The Commission has issued the enclosed Amendments No. 11 to Facility Operating Licenses Nos. DPR-32 and DPR-37 for the Surry Power Station, Units 1 and 2. The amendments include Change No. 26 to your Technical Specifications for each license and are in response to your request dated September 8, 1975, as supplemented October 22, 1975. and October 30, 1975.

The amendments revise the provisions in the Technical Specifications relating to the replacement of 81 of 157 fuel assemblies in the reactor core, constituting refueling of the core for third cycle operation of Unit 1.

ATTACHMENT TO LICENSE AMENDMENT NO. 11

CHANGE NO. 26 TO THE TECHNICAL SPECIFICATIONS

FIGURE 3.12-1A CONTROL BANK INSERTION LIMITS FOR 3-LOOP
NORMAL OPERATION-UNIT 1

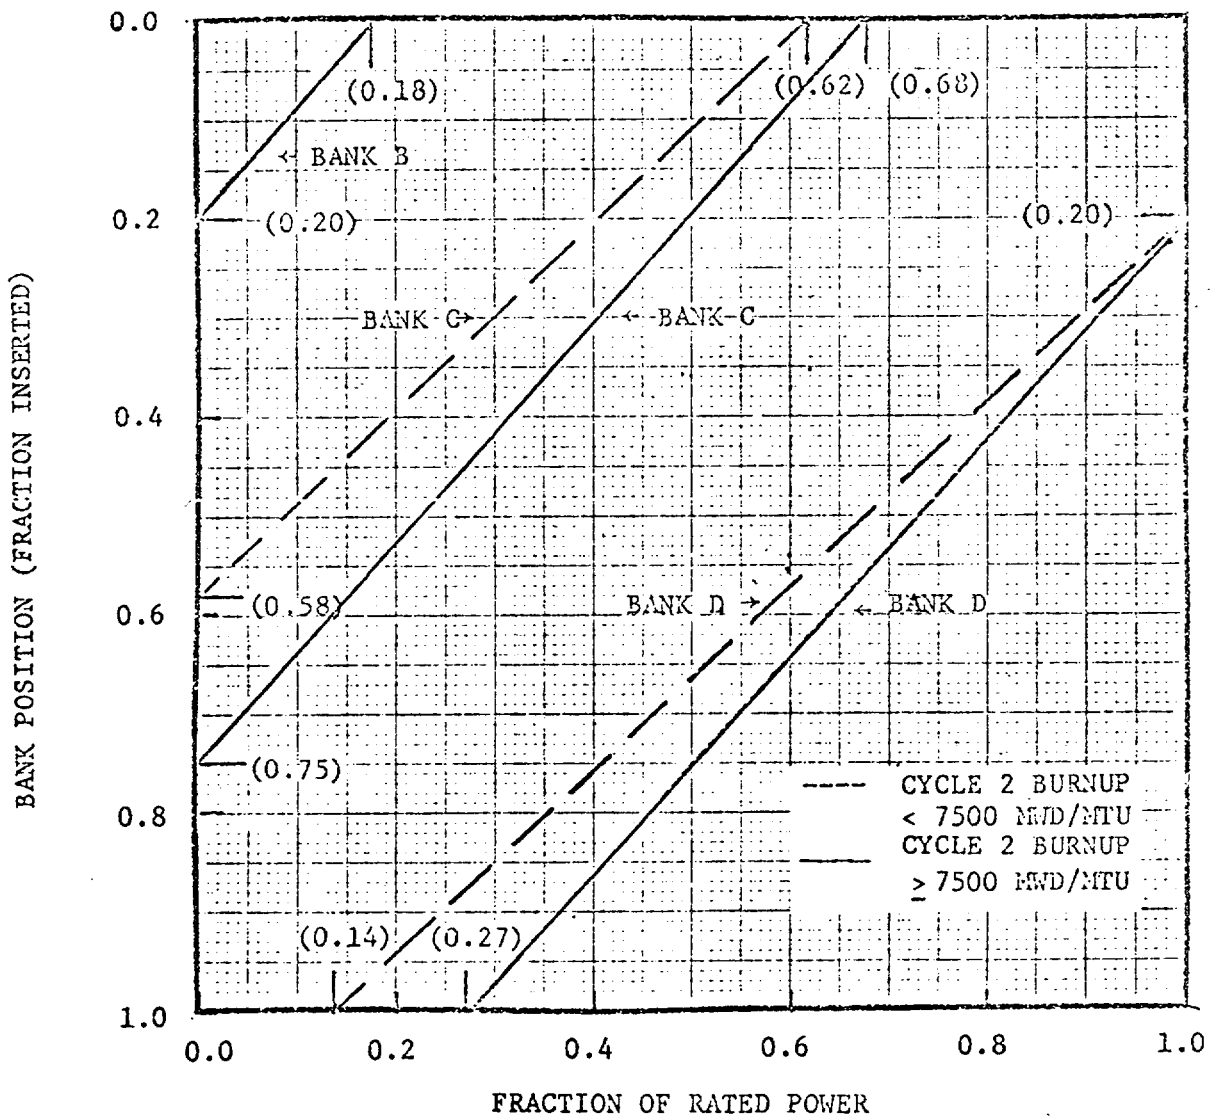
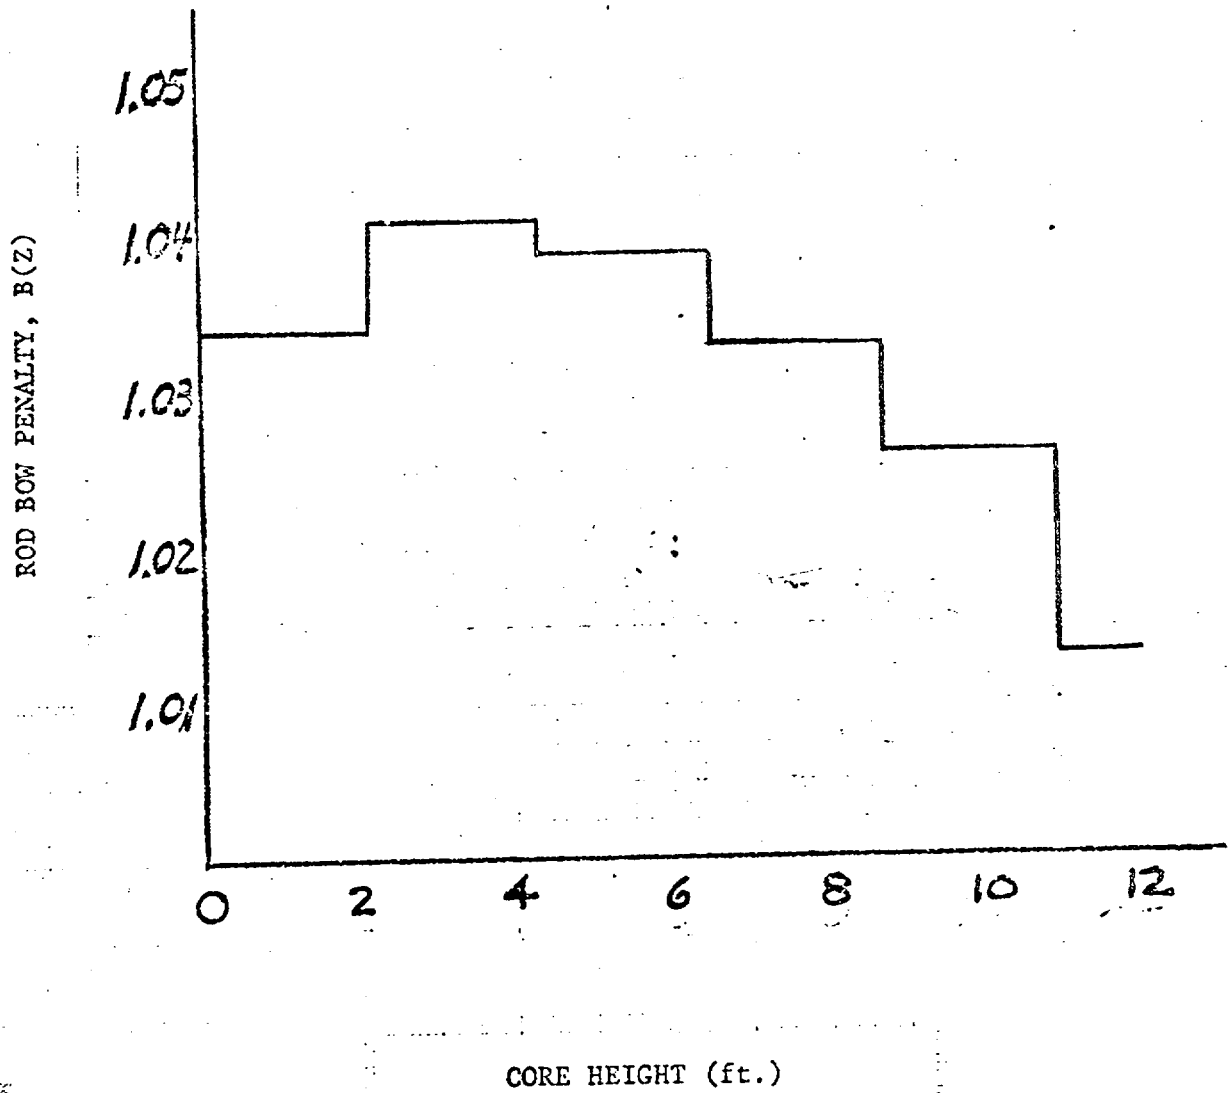
The specified control rod insertion limits have been revised to limit the potential ejected rod worth in order to account for the effects of fuel densification.

2. Control rod banks are sequenced with overlapping banks as shown in Figures 3.12-1A, 3.12-1B and 3.12-2.
3. The full length and part length control bank insertion limits are not violated.
4. For Surry Unit 1, the total cumulative cycle energy weighted average D bank insertion limit is observed.
5. Axial power distribution control procedures, which are given in terms of flux difference control and control bank insertion limits are observed. Flux difference refers to the difference between the top and bottom halves of two-section excore neutron detectors. The flux difference is a measure of the axial offset which is defined as the difference in normalized power between the top and bottom halves of the core.

FIGURE 3.12-1A CONTROL BANK INSERTION LIMITS FOR 3-LOOP
NORMAL OPERATION-UNIT 1

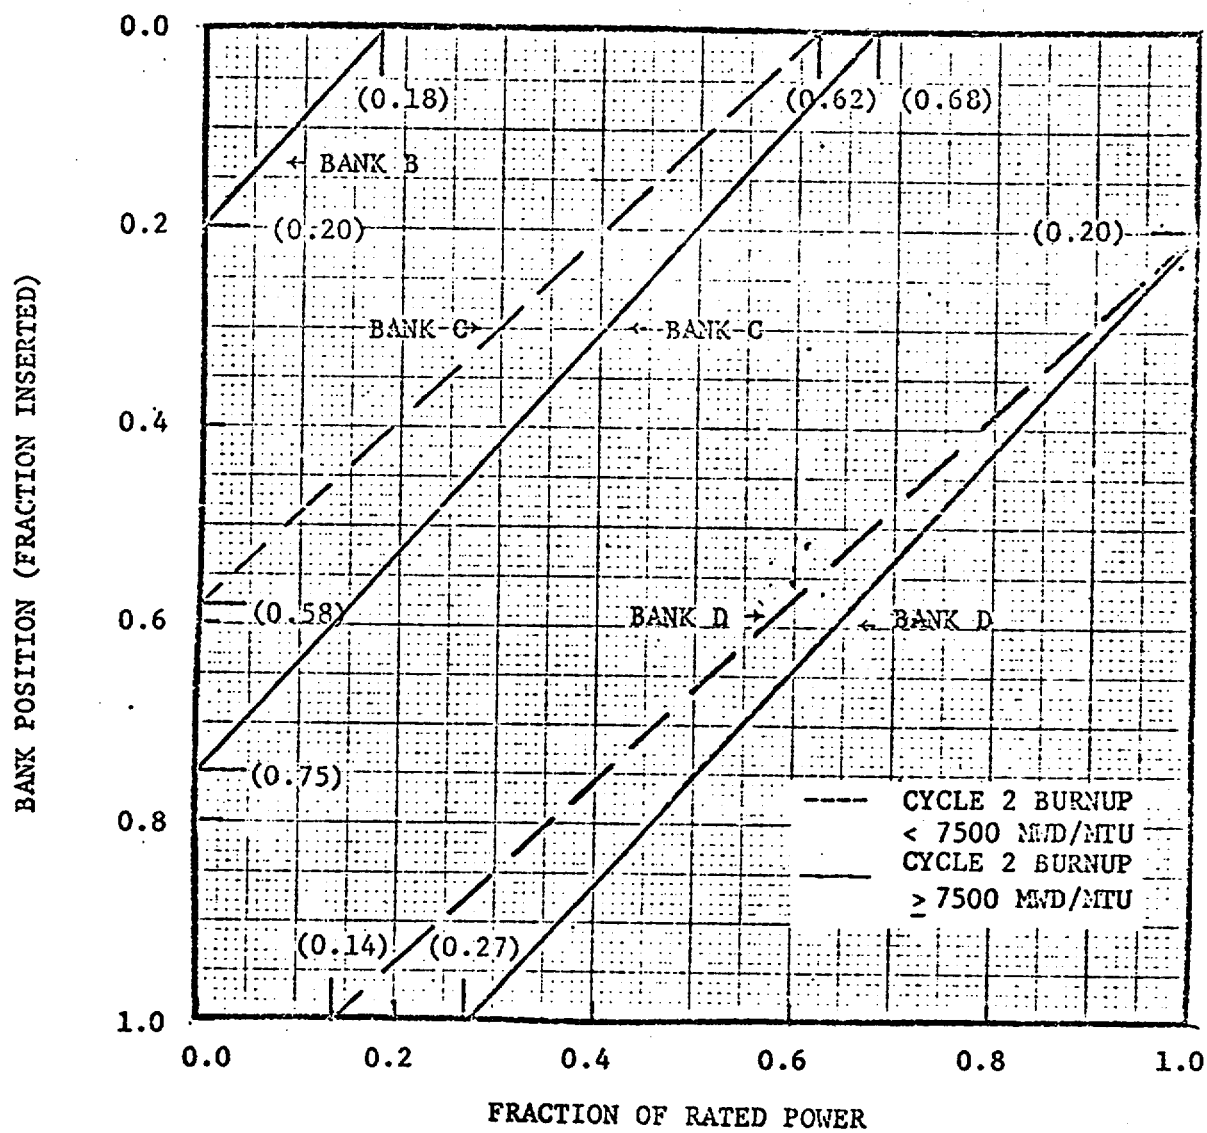
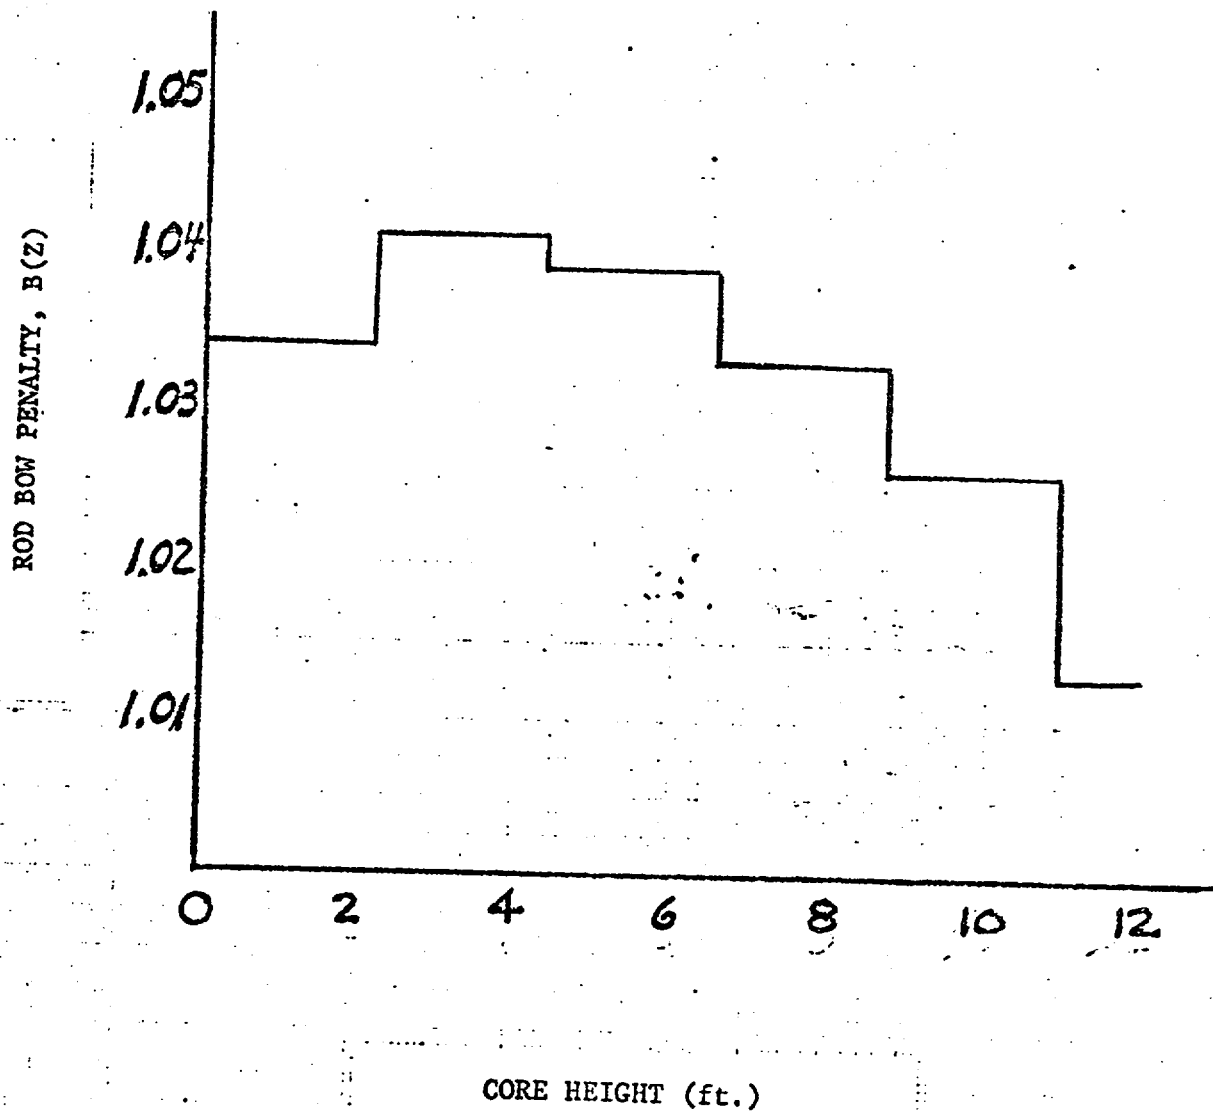
The specified control rod insertion limits have been revised to limit the potential ejected rod worth in order to account for the effects of fuel densification.
